DuraVent[®] - DuraTech[®]: New Chimney Cap Assembly L1510 Installation Instruction Addendum

Assembly Process

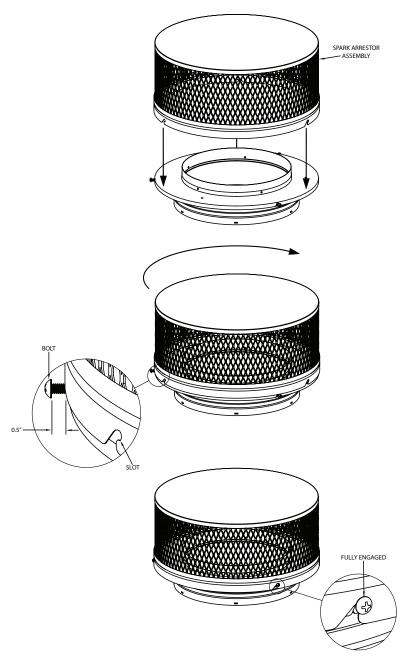
Spark Arrestor Assembly Installation/Removal: To remove the Spark Arrestor Assembly for cleaning, loosen the three bolts that attach it without fully removing them, then twist the spark arrestor assembly counter-clockwise while lifting upwards. To reinstall, lower the spark arrestor assembly onto the three loosened bolts (without aligning the slots and bolts), then twist the spark arrestor assembly clockwise until the slots drop onto the bolts. Ensure that the bolts are fully engaged in the slots, then tighten the bolts to secure the spark arrestor assembly.
